RESOLUTION NO. 201559

RESOLUTION OF THE COUNCIL OF THE CITY  
OF SAN DIEGO, CALIFORNIA, ORDERING  
CHANGES IN THE ASSESSMENT, DIAGRAM,  
PLANS AND SPECIFICATIONS.

(Centre City Way Assessment District)

ADDENDUM "A"

ASSESSMENT DIAGRAM FOR THE WORK AND IMPROVEMENT OF:  
 Centre City Way

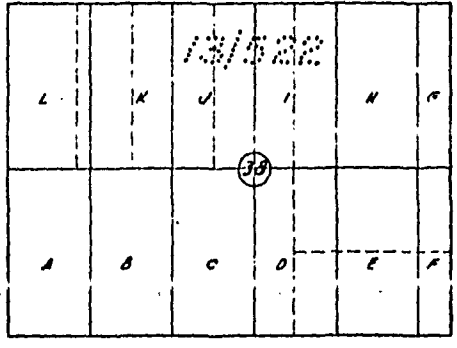
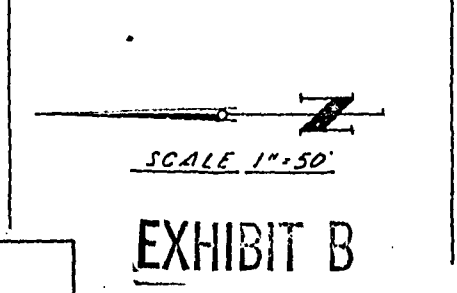
1. Assessment Parcels 20, 21 and 22 revised comprising property as follows:

(Exhibit "B", copy of diagram, attached)

NOTES:  
 1. PARCEL NUMBERS SHOWN AS 533-522-6 ARE COUNTY ASSESSOR PARCEL NUMBERS. THEY ARE FOR INFORMATION ONLY AND ARE NOT TO BE USED IN THE LEGAL DESCRIPTION OF PROPERTIES.  
 2. ASSESSMENT NUMBERS AS SHOWN \*1  
 3. ASSESSMENT NO. \*22 OMITTED.

**CITY OF SAN DIEGO, CALIFORNIA**  
 PROJECT NO. 33699  
 SHEET NO. 1201559  
 DATE 200-1719  
 12003-68-D

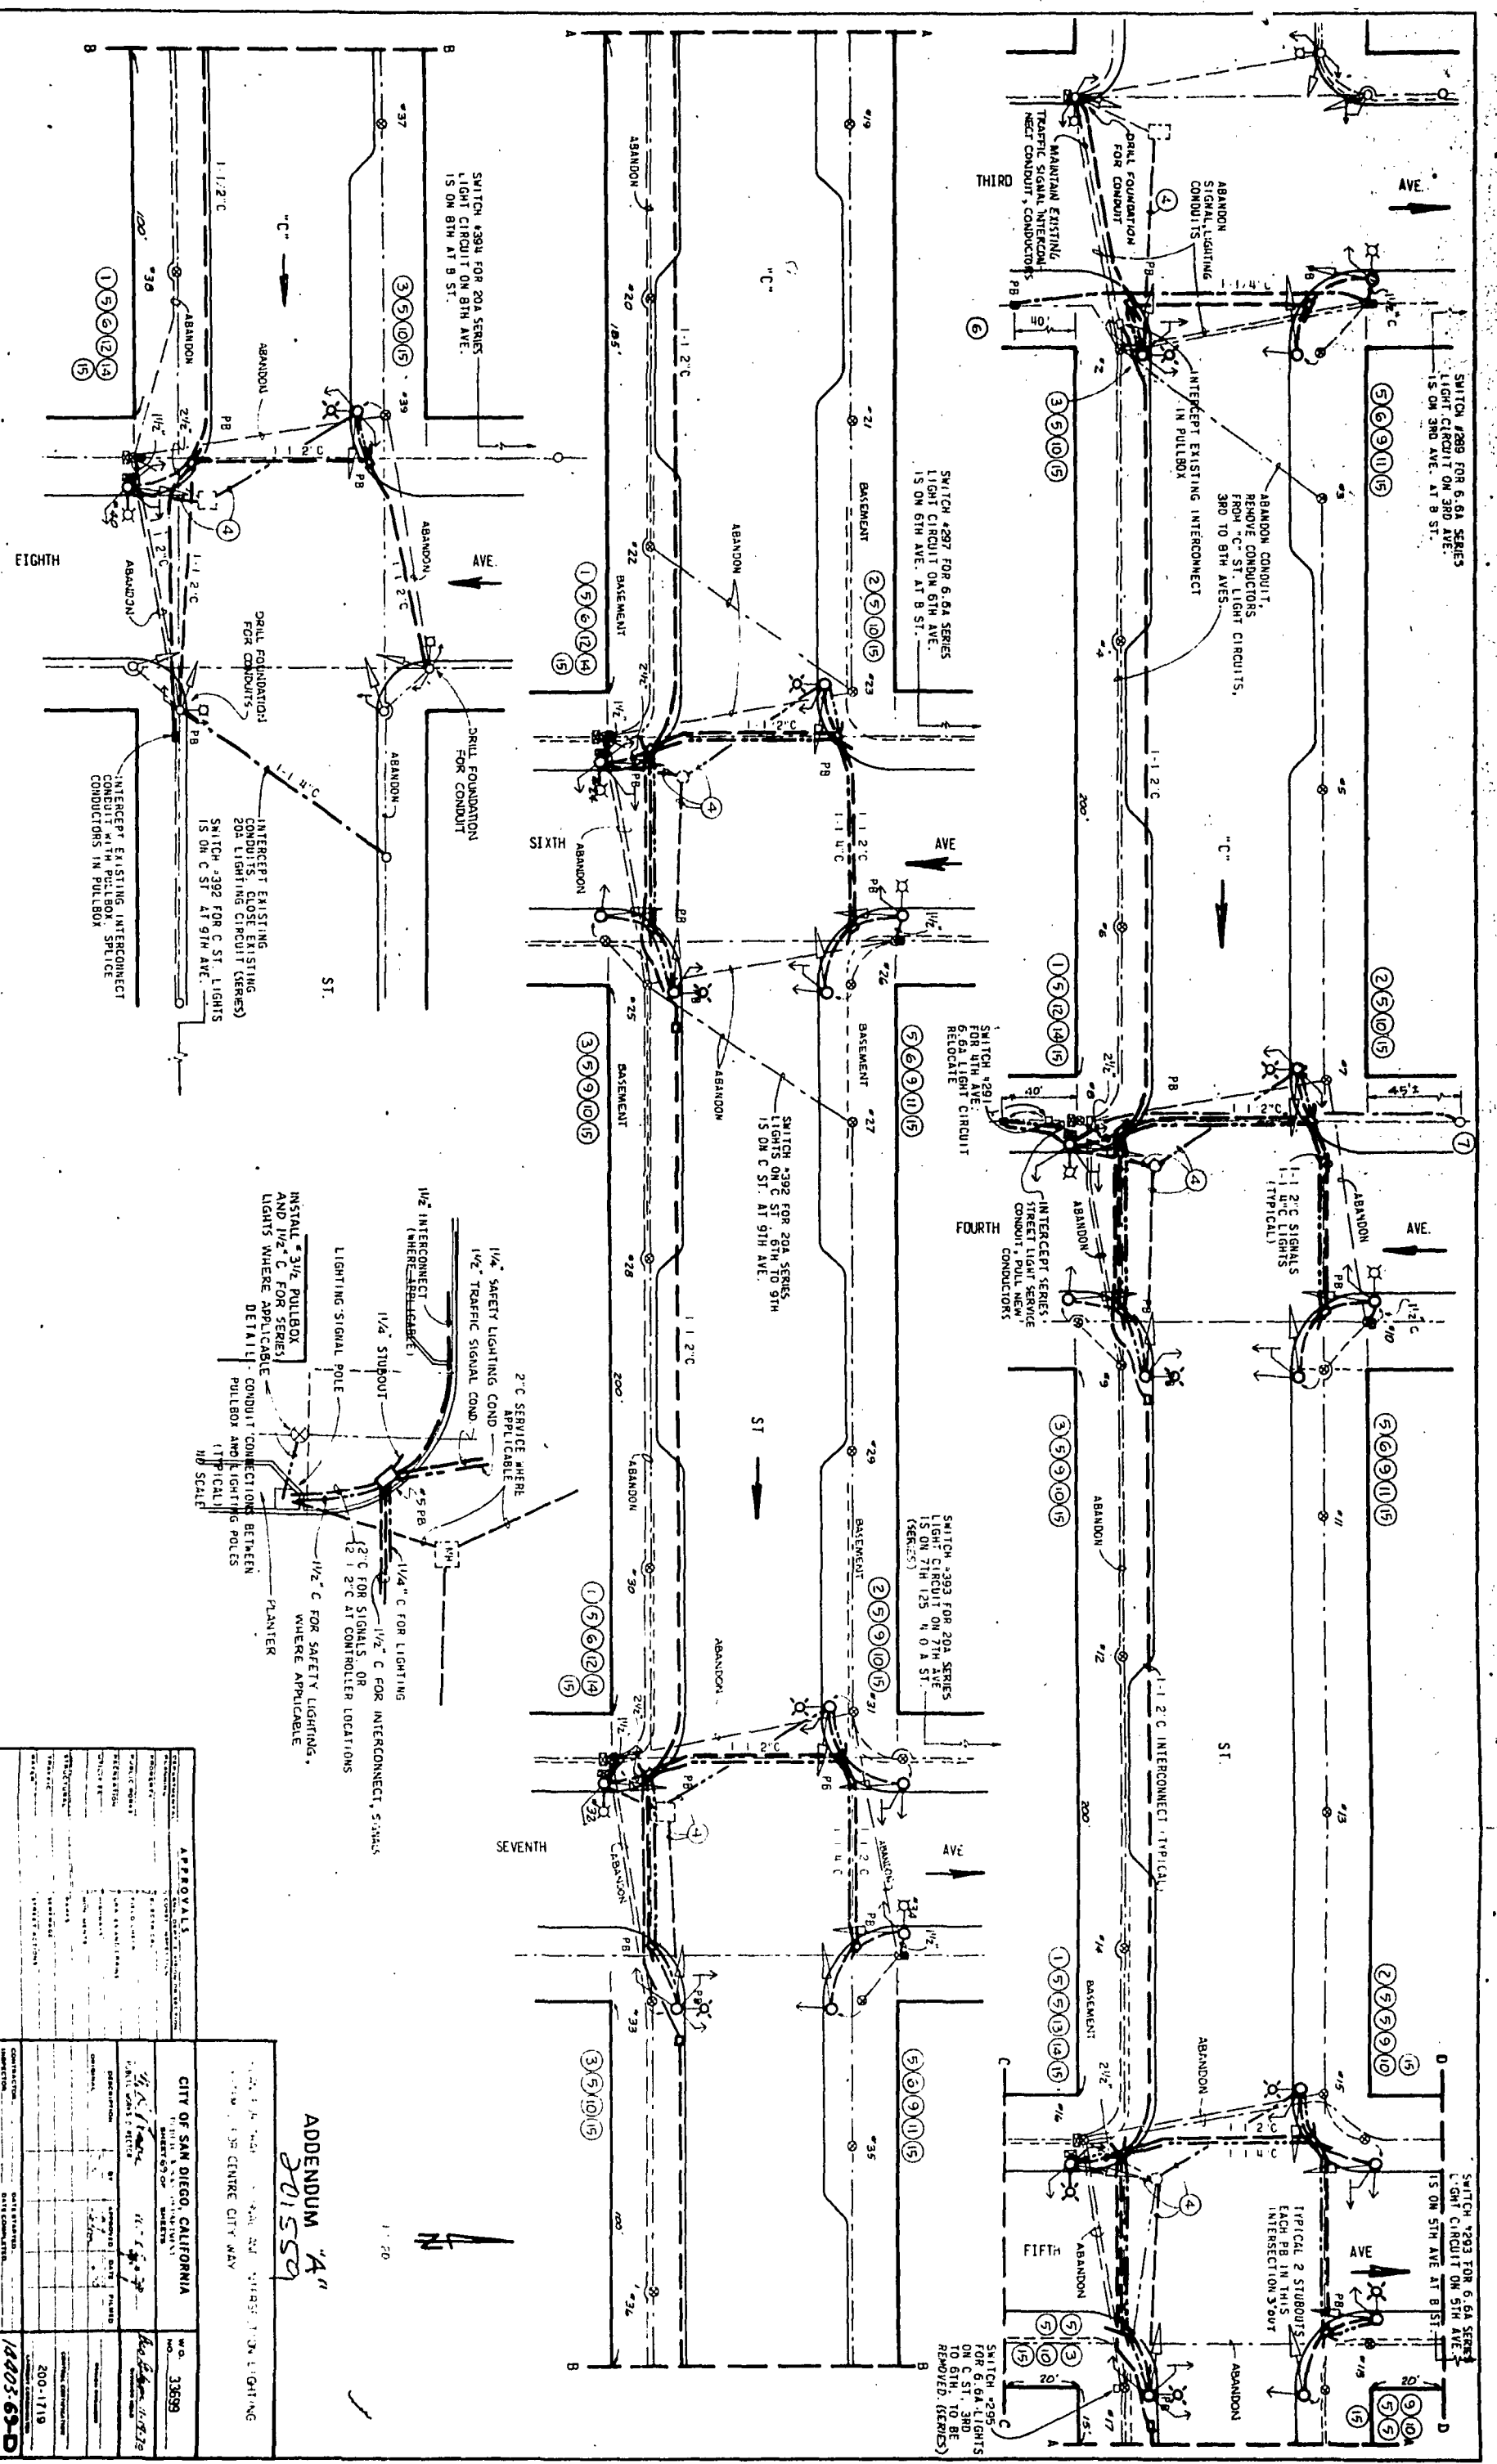
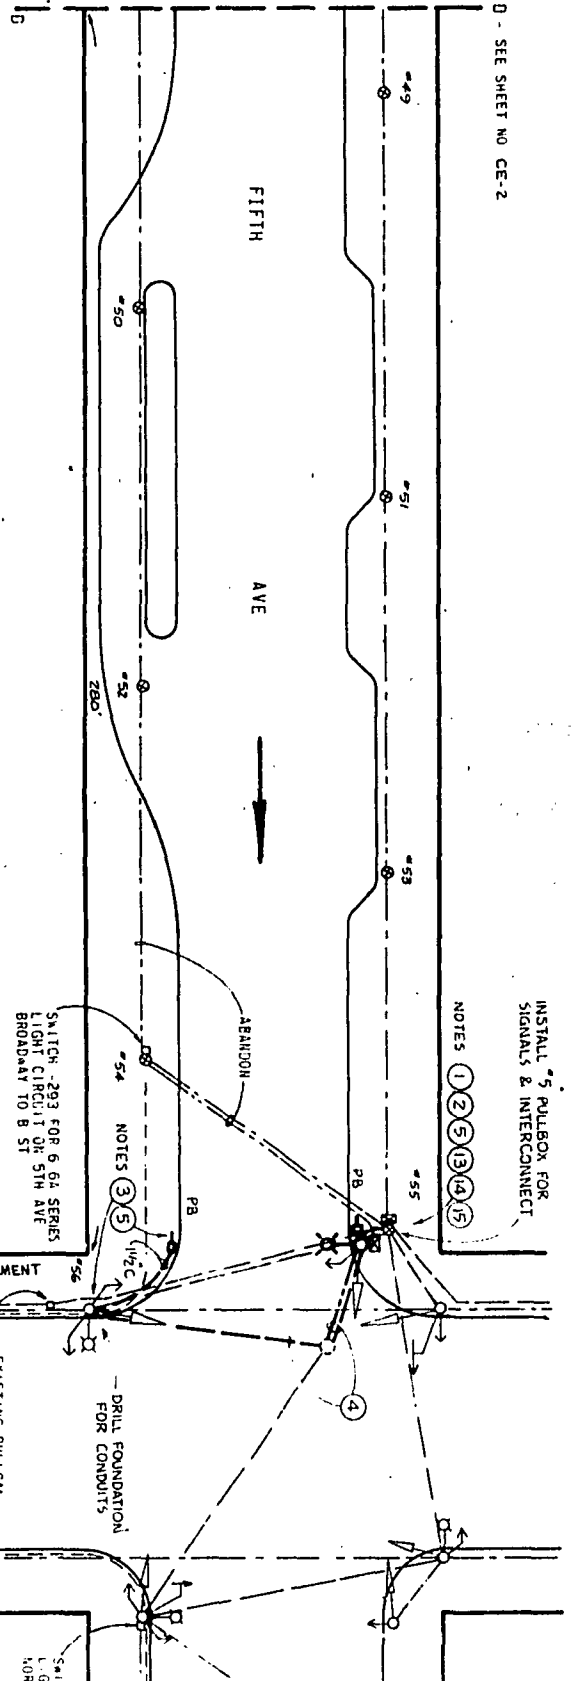
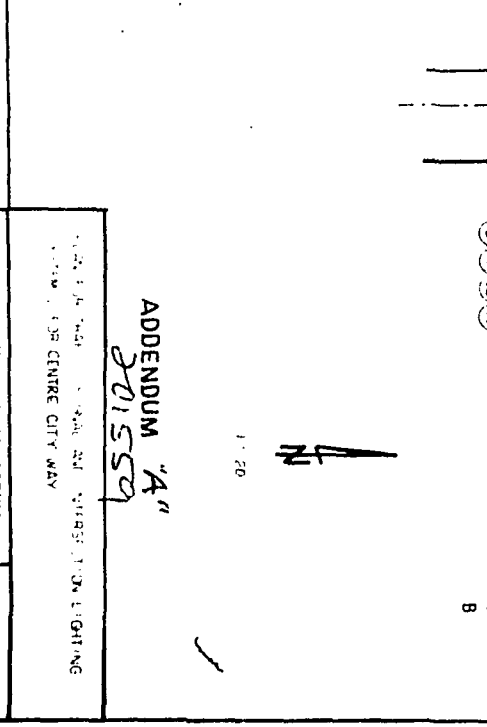
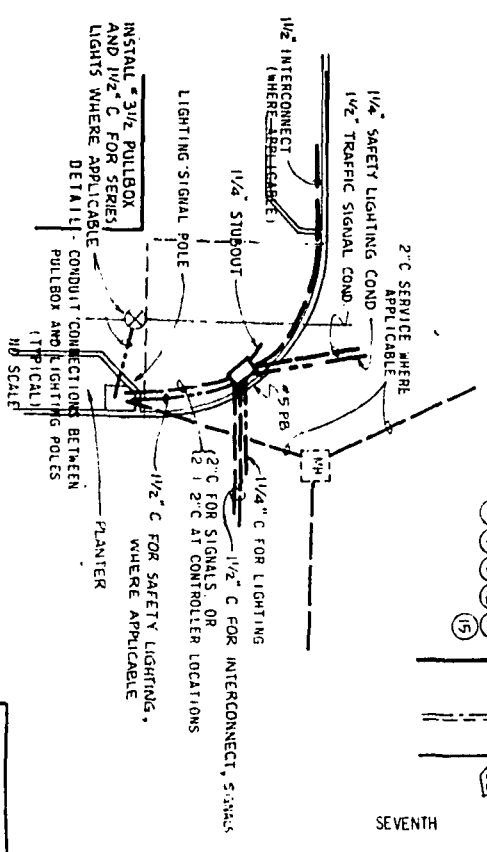
New drawing numbers 14403-68-D and 14403-69-D accompany this Addendum and are made a part of the detail plans issued with the bid package.

(2) Item No. 62 "Traffic Signal and Safety Lighting System" for substitution of the alternate system as shown on Drawings 68 and 69 at a new lump sum price,

The purpose of Deductive Alternate No. 4 is to delete the specified requirement for the traffic signal columns as shown on Drawings 34, 35, 36 and 37, which were to be installed at intersection locations as shown on Drawings 50 and 51. An integral part of the Deductive Alternate is the relocation of existing traffic signal equipment utilizing salvaged material to the greatest possible extent as shown on new Drawings 14403-68-D and 69-D.
